COLORADO DIVISION OF RECLAMATION, MINING AND SAFETY MINERALS PROGRAM INSPECTION REPORT

MINE NAME:	MINE/PROSPECTING ID#:	MINERAL:	COUNTY:
Hard Rock 291 Pit	M-1977-195	Sand and gravel	Chaffee
INSPECTION TYPE:	INSPECTOR(S):	INSP. DATE:	INSP. TIME:
Monitoring	Dustin M. Czapla	September 10, 2014	15:30
OPERATOR:	OPERATOR REPRESENTATIVE:	TYPE OF OPERATION:	
Hard Rock Paving and Redi-Mix, Inc.	None	110c - Construction Limited Impact

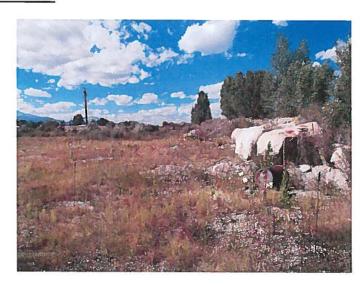
There has been no mining at this site since at least 2003. Volunteer vegetation is well established throughout the permit area. However, reclamation grading and topsoil application have not been completed. Rule 3.1.3 requires that all reclamation be carried to completion by the Operator with all reasonable diligence within five years of completing mining. This has been noted above as a problem. The site has been approved for intermittent operations, which applies to operations that operate less than 180 days per year. This site, however, has not operated for more than ten years and the operator has provided no indication to the Division for planning to resume operations.

CORRECTIVE ACTIONS: Commence and complete reclamation of the site in accordance with the approved reclamation plan, Act and Rules.
